COUNTY OF LOS ANGELES
DEPARTMENT OF PUBLIC WORKS

**PROPOSED 2011 LOS ANGELES COUNTY
RESIDENTIAL CODE
(ALL SUPERVISORIAL DISTRICTS)
(3 VOTES)**

ORDINANCE NO. _____

An ordinance adding Title 30 – Residential Code to the Los Angeles County Code, relating to the adoption of the 2010 California Residential Code by reference, with certain changes and modifications.

FIGURE R403.1.5

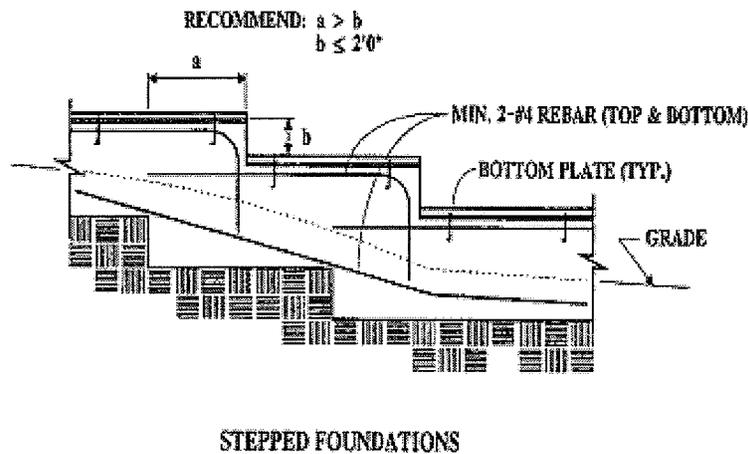
For structures located in Seismic Design Categories D₀, D₁, or D₂, stepped footings shall be reinforced with two No. 4 deformed reinforcing bars located at the top and bottom of the footings as shown in Figure R403.1.5.

FIGURE R602.10.3.3

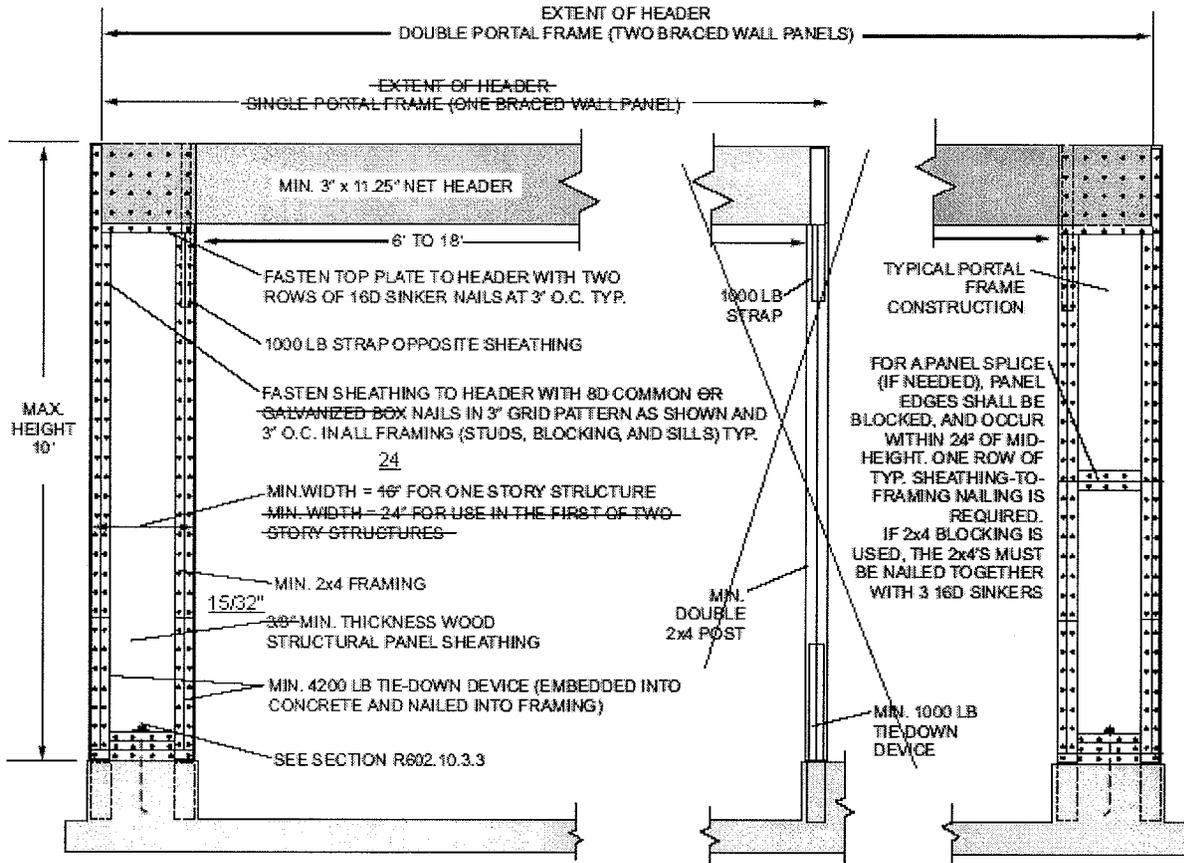
The wood structural panel sheathing shall extend up over the solid sawn or glued-laminated header and shall be nailed in accordance with Figure R602.10.3.3. A spacer, if used with a built-up header, shall be placed on the side of the built-up beam opposite the wood structural panel sheathing. The header shall extend between the inside faces of the first full-length outer studs of each panel. One anchor bolt not less than 5/8-inch-diameter (16 mm) and installed in accordance with Section R403.1.6 shall be provided in the center of each sill plate. The hold-down devices shall be an embedded-strap type, installed in accordance with the manufacturer's recommendations. The panels shall be supported directly on a foundation that is continuous across the entire length of the braced wall line. The foundation shall be reinforced as shown on Figure R602.10.3.2. This reinforcement shall be lapped not less than 4524 inches (~~3846~~10 mm) with the reinforcement required in the continuous foundation located directly under the braced wall line.

SECTION 42. Figure R602.10.3.3 is hereby amended to read as follows:

R602.10.3.3	Geological	The proposal to change the minimum lap splice requirement is consistent with Section 12.16.1 of ACI 318-05.
Figure R602.10.3.3	Geological	3/8" thick 3 ply-plywood shear walls experienced many failures during the Northridge Earthquake. The poor performance of such shear walls sheathed in the 1994 Northridge Earthquake was investigated by the Structural Engineers Association of Southern California (SEAOSC) and the Los Angeles City Task Force. The cities and county of the Los Angeles region have taken extra measures to maintain the structural integrity of the framing of the shear walls when designed for high levels of seismic loads. Box nails were observed to cause massive and multiple failures of the typical 3/8-inch thick plywood during the Northridge Earthquake. This proposed amendment continues amendments adopted during the previous code cycle for the California Building Code.

**TABLE R602.10.4.1
CONTINUOUS SHEATHING METHODS**

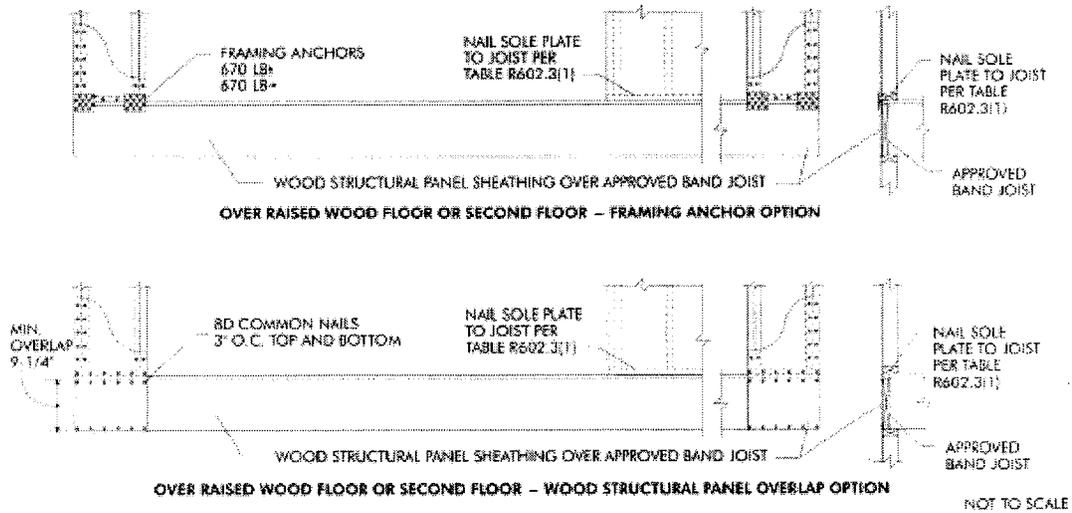
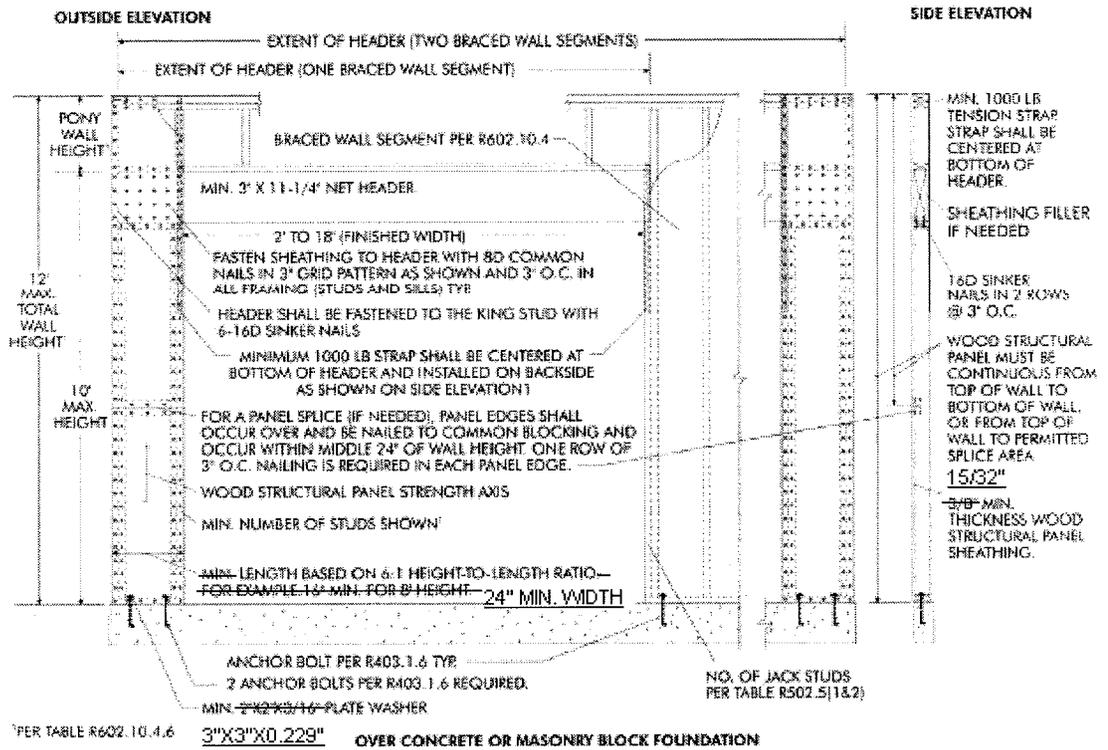
METHOD	MATERIAL	MINIMUM THICKNESS	FIGURE	CONNECTION CRITERIA
CS-WSP	Wood structural panel	$\frac{15}{32}$ " $\frac{3}{8}$ "		6d common (2" x 0.113") nails at 6" spacing (panel edges) and at 12" spacing (intermediate supports) or 16 ga. x 1 3/4" staples at 3" spacing (panel edges) and 6" spacing (intermediate supports) ^c
CS-G	Wood structural panel adjacent to garage openings and supporting roof load only ^{a,b}	$\frac{15}{32}$ " $\frac{3}{8}$ "		See Method CS-WSP
CS-PF	Continuous portal frame	See Section R602.10.4.1.1		See Section R602.10.4.1.1

Code Section	Condition	Explanation of Amendment
Table R602.10.4.1	Geological	<p>3/8" thick 3 ply-plywood shear walls experienced many failures during the Northridge Earthquake. The poor performance of such shear walls sheathed in the 1994 Northridge Earthquake was investigated by the Structural Engineers Association of Southern California (SEAOSC) and the Los Angeles City Task Force. The cities and county of the Los Angeles region have taken extra measures to maintain the structural integrity of the framing of the shear walls when designed for high levels of seismic loads. This proposed amendment continues the previous amendment adopted during the 2007 code adoption cycle for the California Building Code. In September 2007, limited cyclic testing data was provided to the ICC Los Angeles Chapter Structural Code Committee showing that stapled wood structural shear panels do not exhibit the same behavior as the nailed wood structural shear panels. As a matter of fact, the test results of the stapled wood structural shear panels appeared much lower in strength and drift than the nailed wood structural shear panel test results. Therefore, the use of staples as fasteners for shear walls sheathed with other materials shall not be permitted without being substantiated by cyclic testing. This proposed amendment is a continuation of an amendment adopted during previous code adoption cycles.</p>
